SR 360 WIDENING
CSSTP-0006-00(049) - P.I. No. 0006049
Cobb and Paulding Counties, Georgia

Value Engineering Study Report
Preliminary Design Stage

re: Project No. CSSTP-0006-00(049), P.I. #0006049
Widening of SR 120/Charles Hardy Parkway to SR 176/Lost Mountain Road
Value Engineering Study Report

ALTERNATIVE No.
P-9
SHEET OF

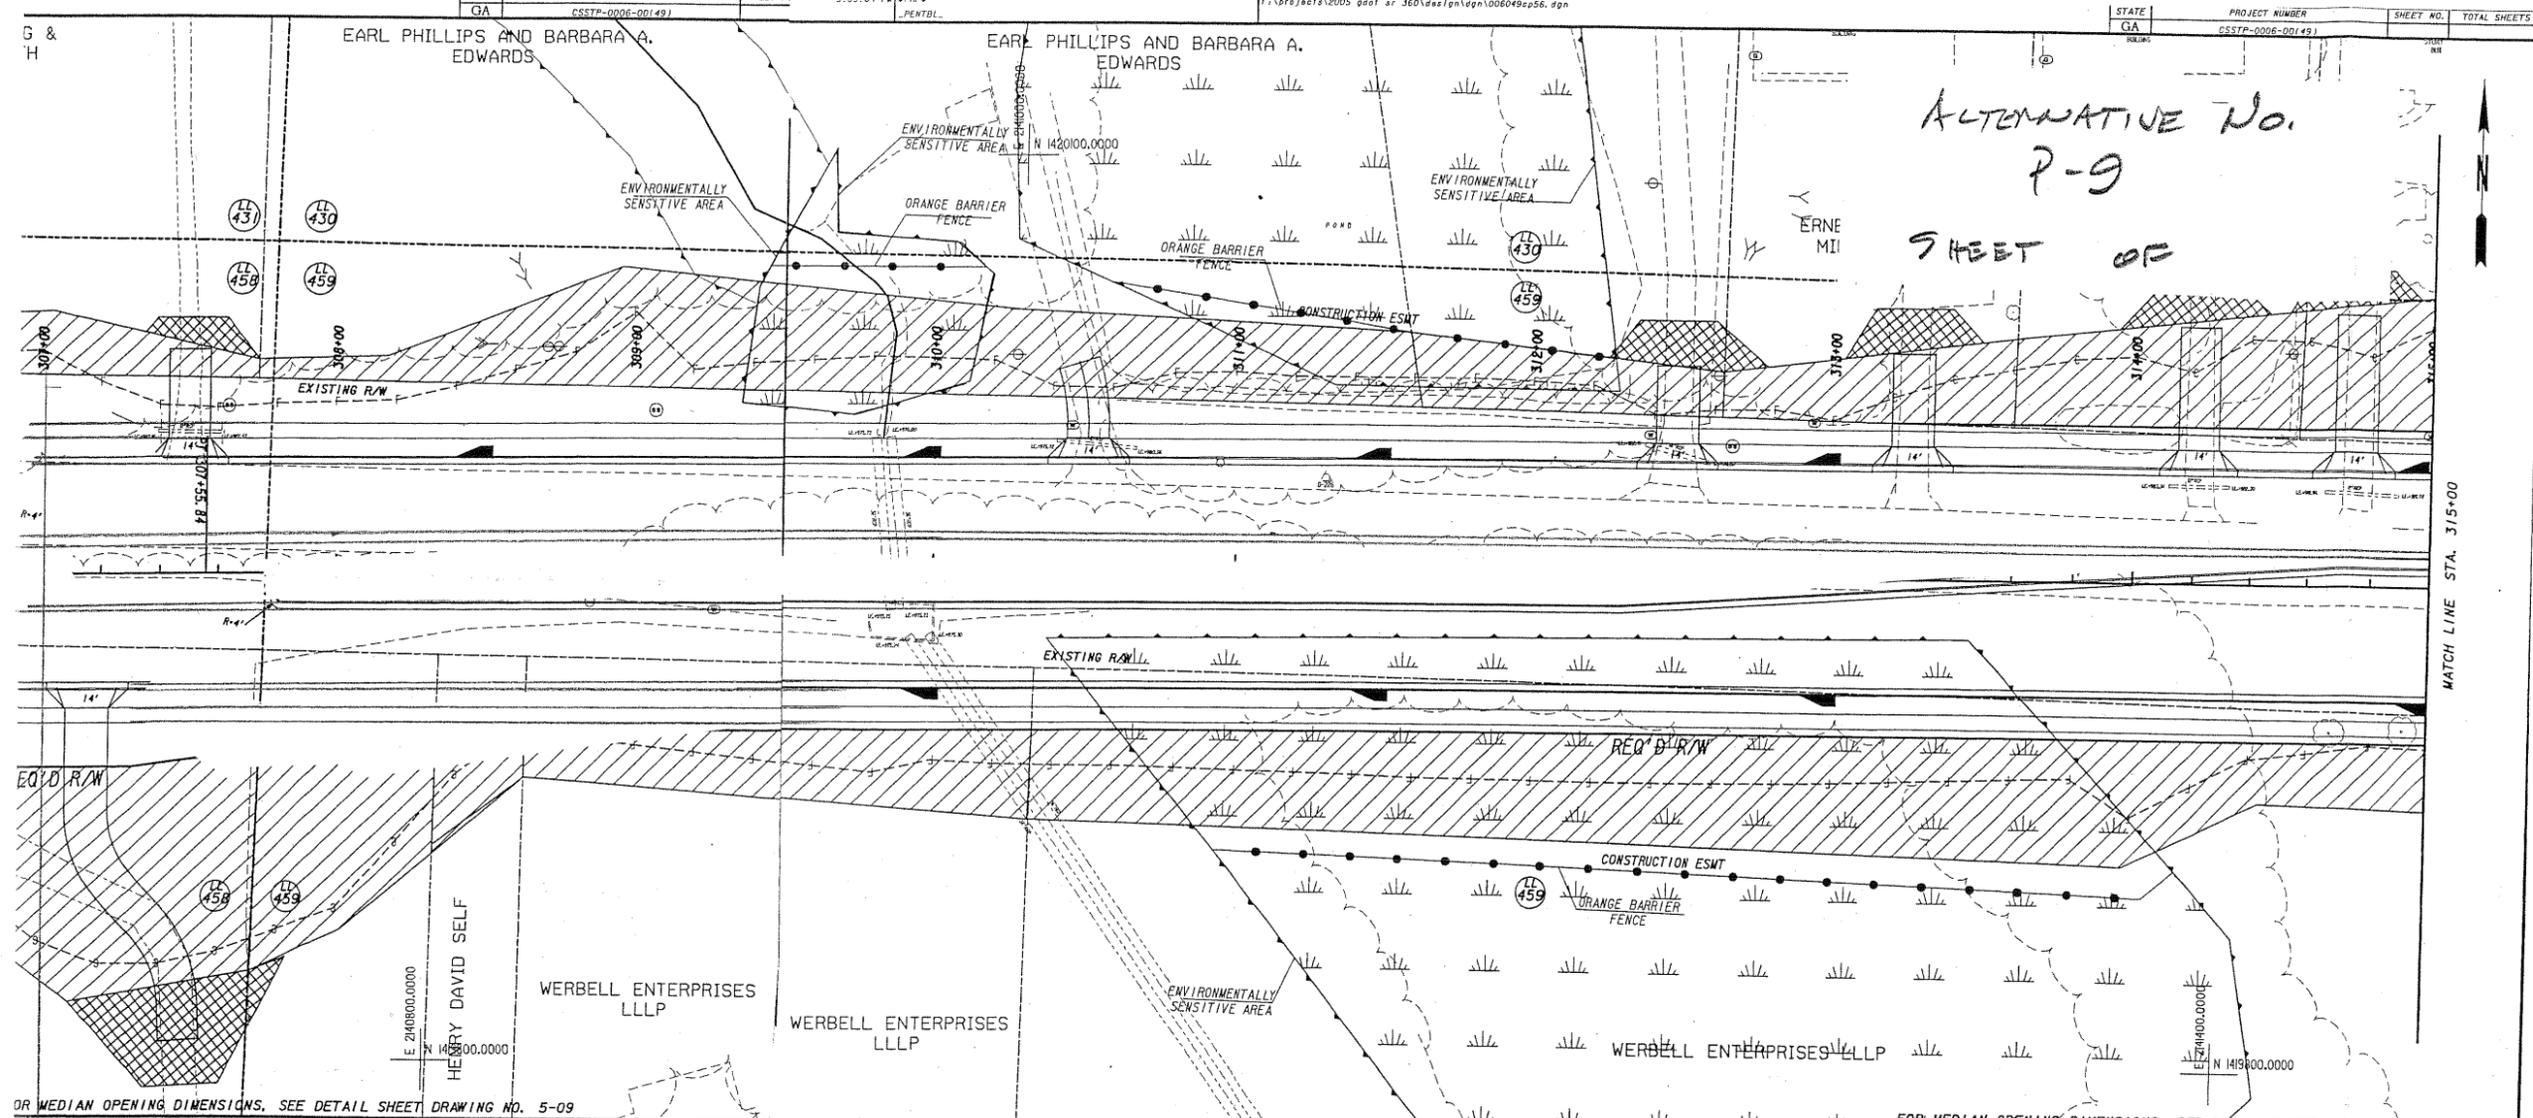
DESCRIPTION: **REMOVE U-TURN AT STATION 307+50**

Delete the U-turn at Station 307+50.

TOTAL EASEMENT SAVED = 15430 SF

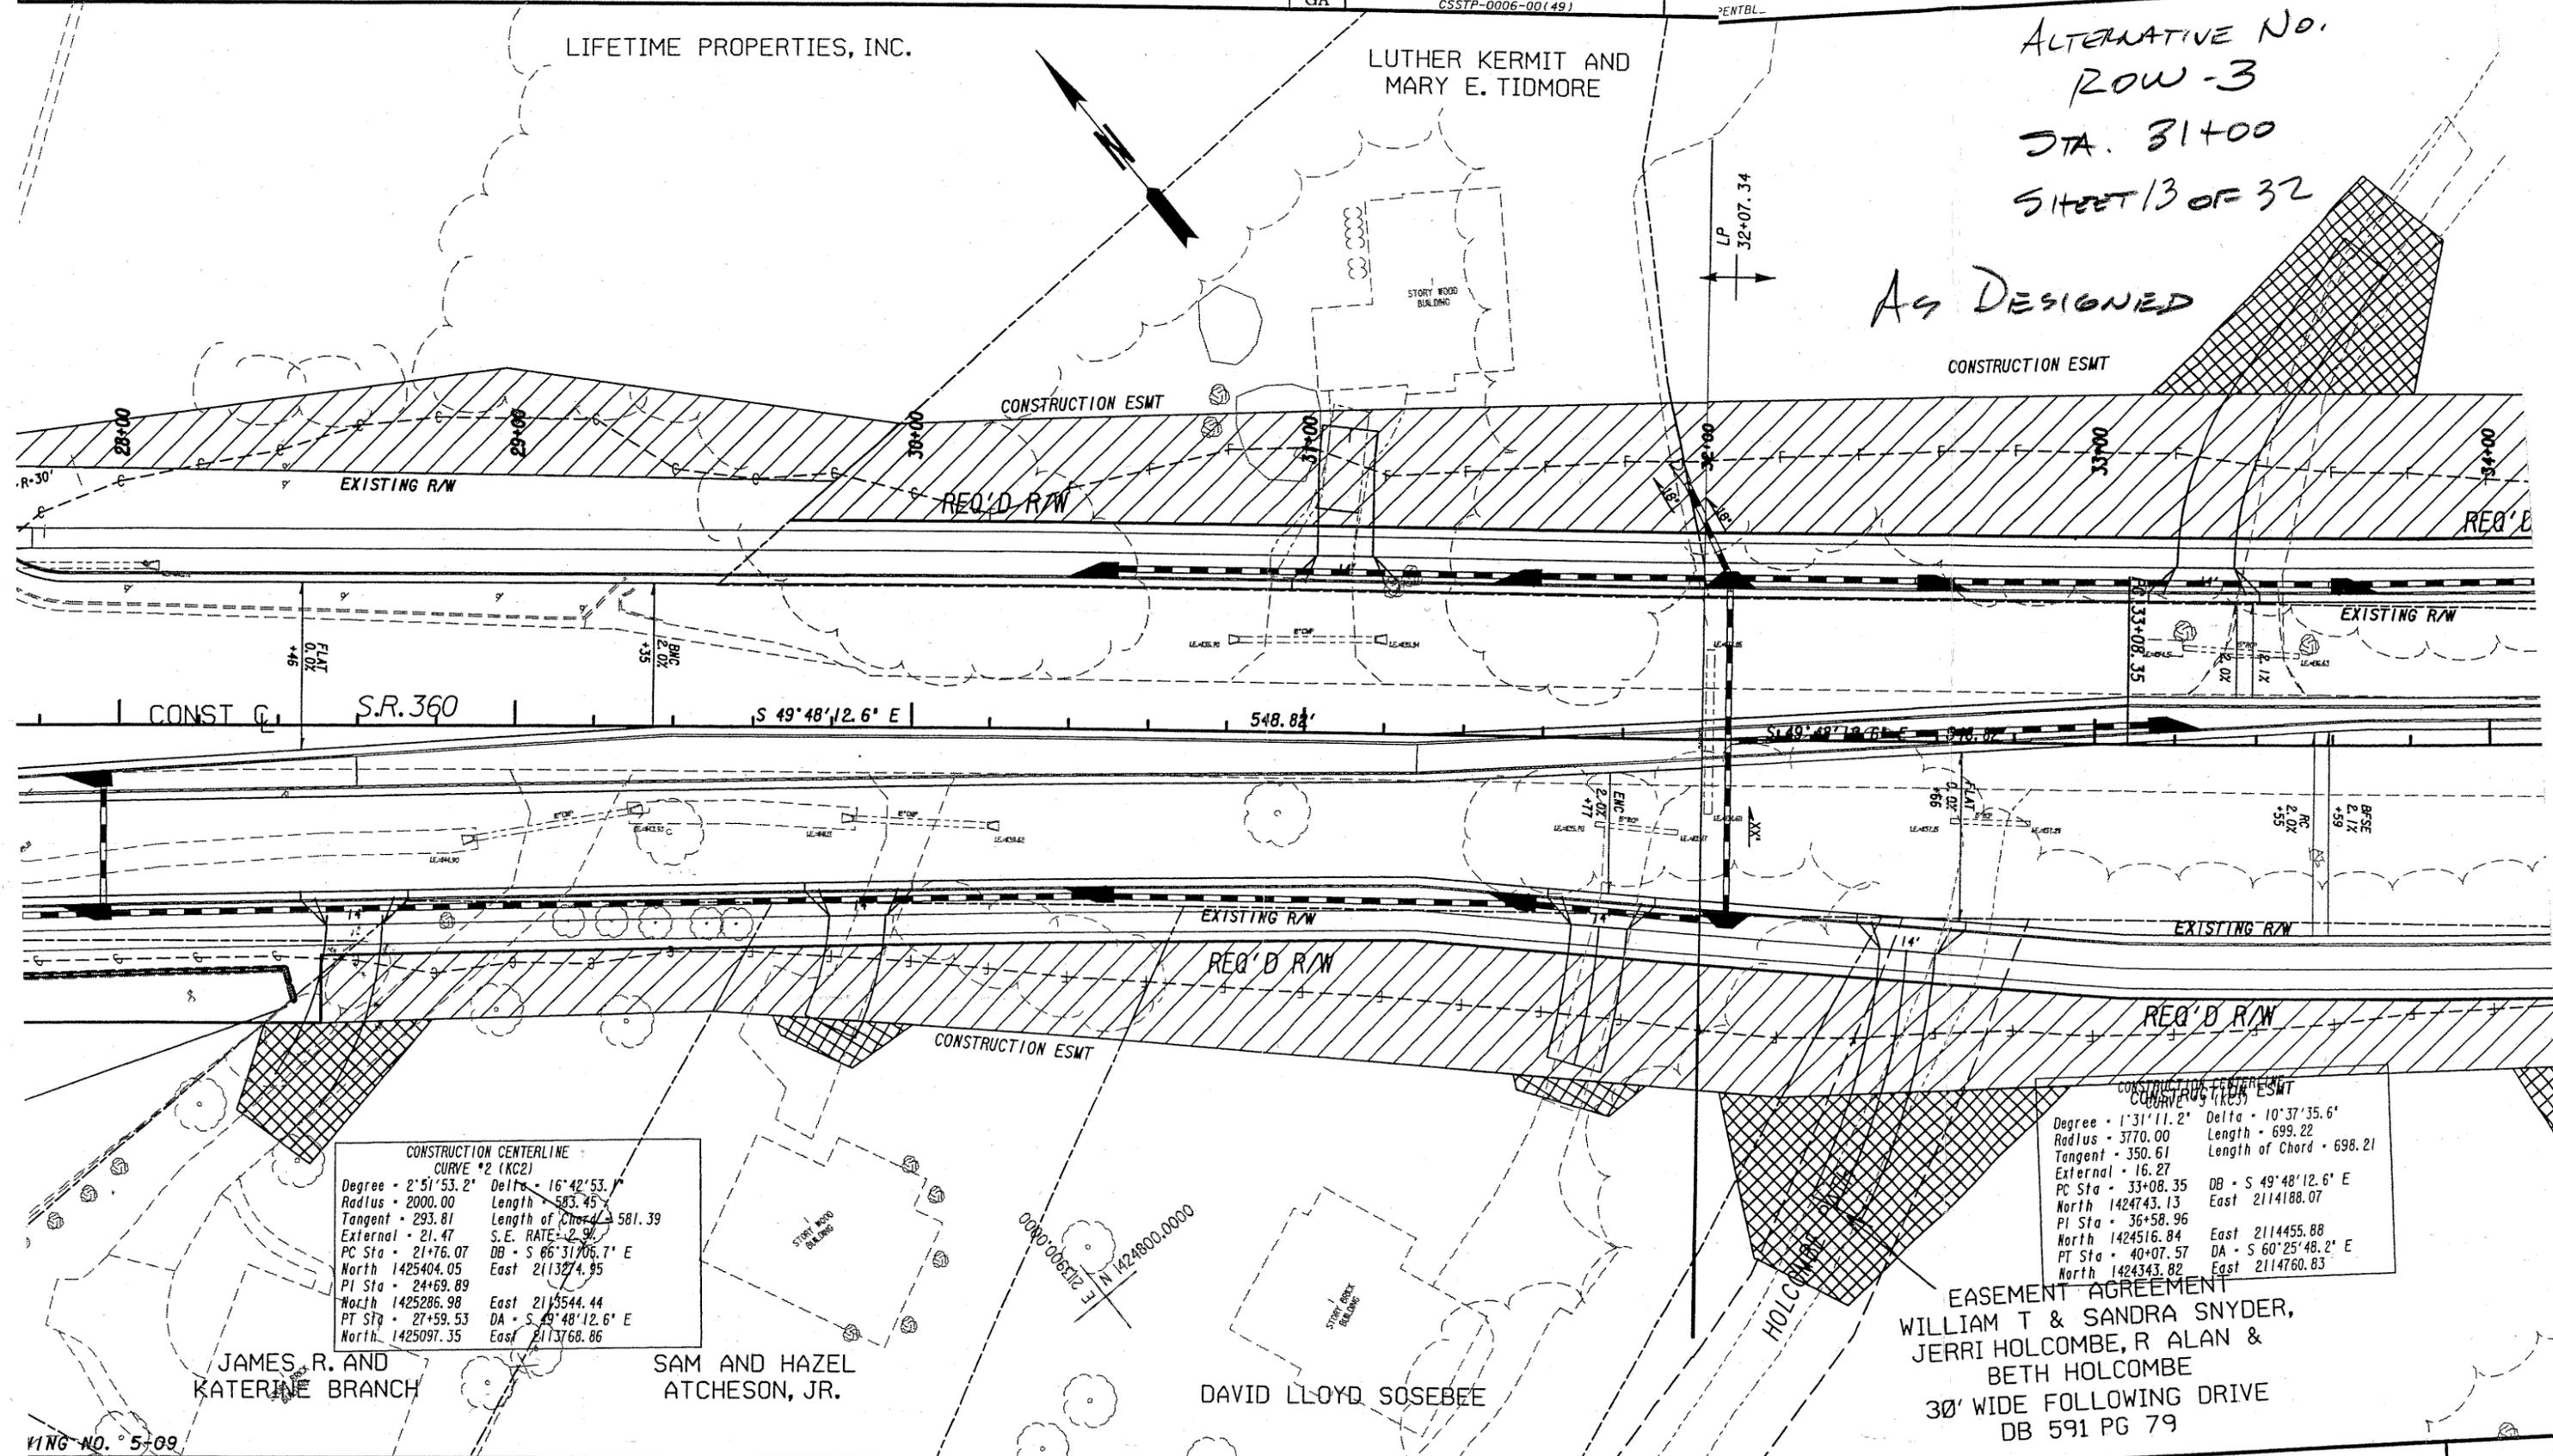
ADD WALL FROM STA 20+30, SR 360 TO STA 28+40, SR 120 AND ELIMINATE SLOPE EASEMENT IN COMMERCIAL PARKING LOT

ALT. NO.
ROW-5
Sht. 2 of 4

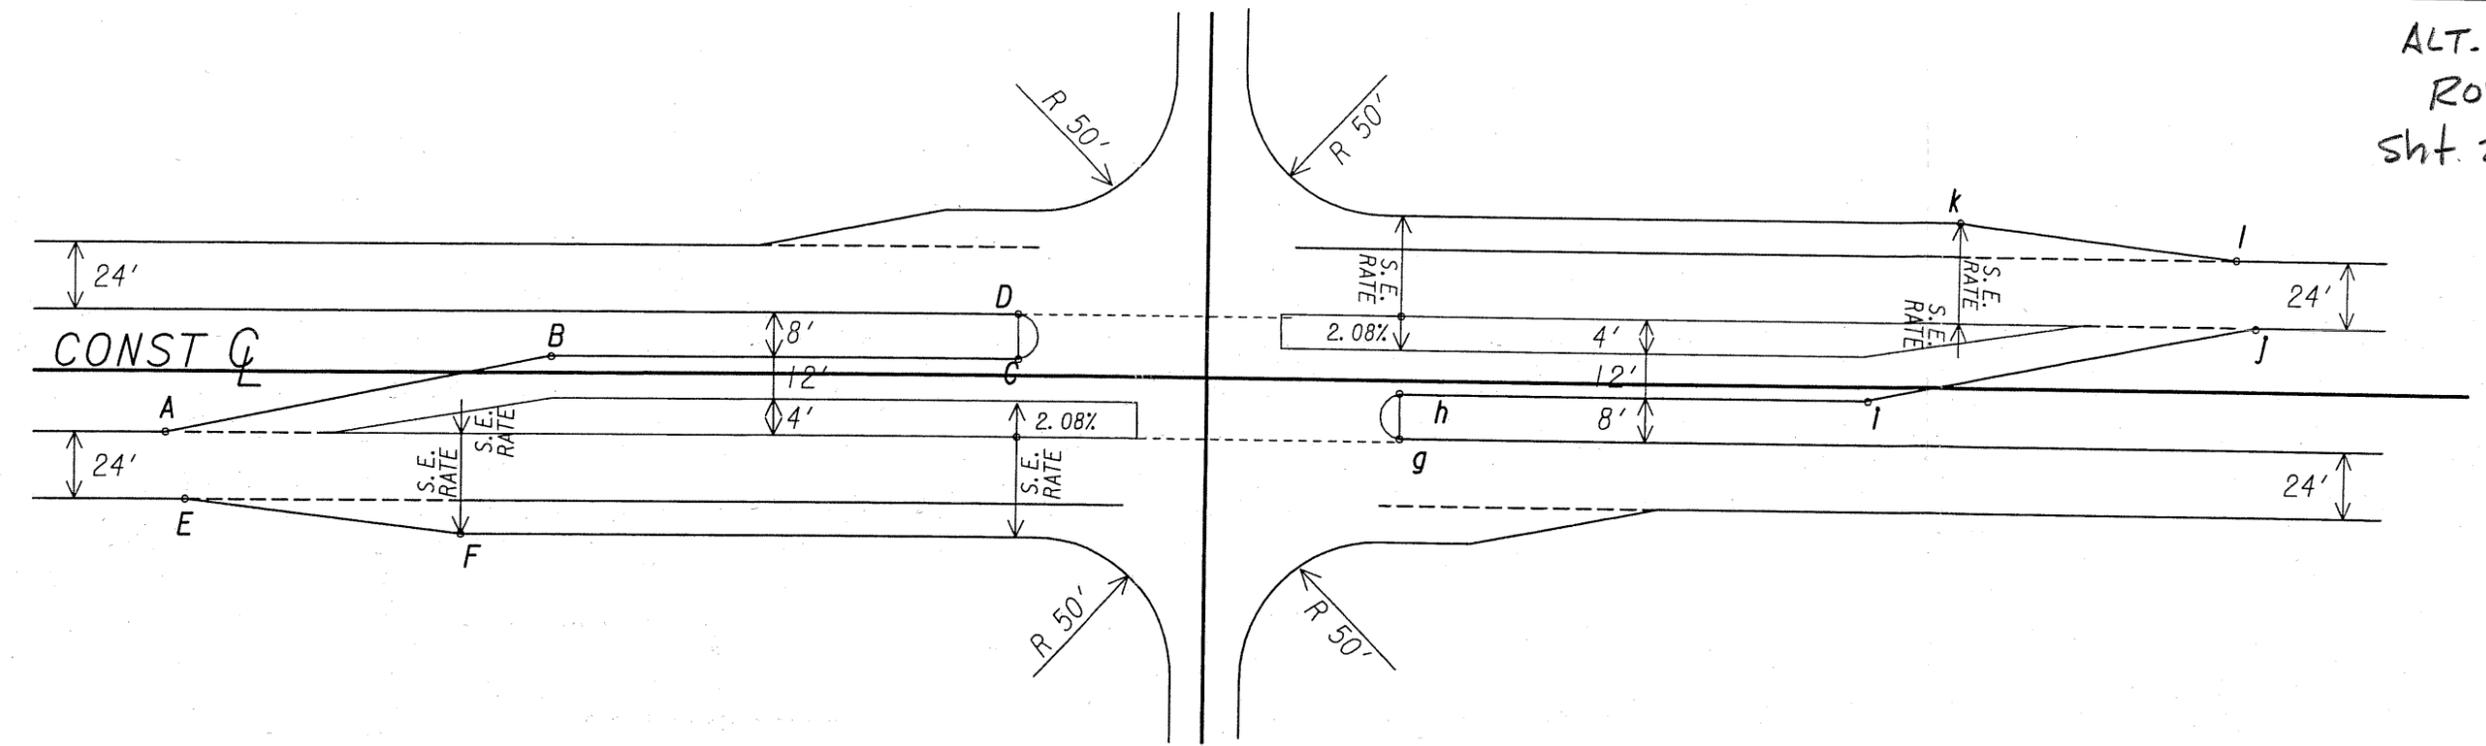
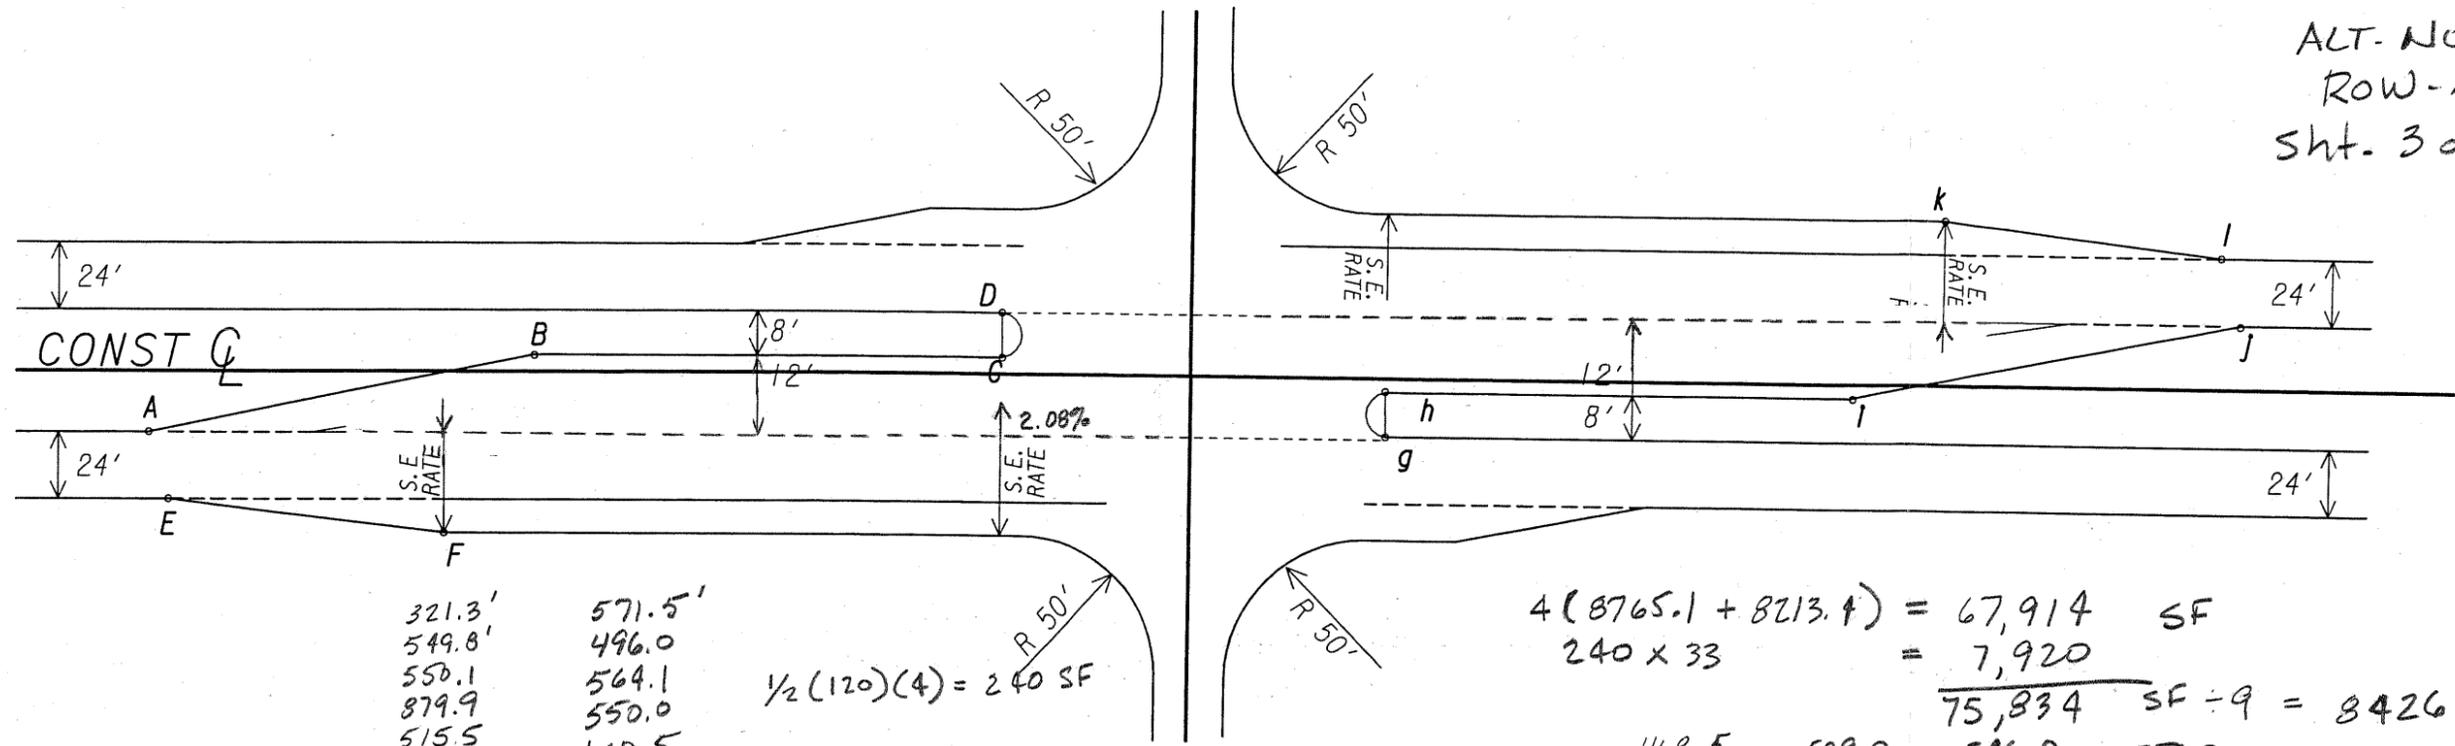
DESCRIPTION: **REDUCE THE WIDTH OF THE MEDIAN FROM 24 FT. TO 20 FT.** SHEET NO.: **1 of 4**

The median width depends upon the room available for the left-turn lanes. Using a 4-ft.-wide buffer zone between the left-turn lane and the through lane adds pavement and right-of-way costs to the project. In many instances, there is no buffer zone between these two lanes. If the proposed approach is taken on this project, significant costs can be saved. With few trucks using this route, the need for a buffer zone is questioned.
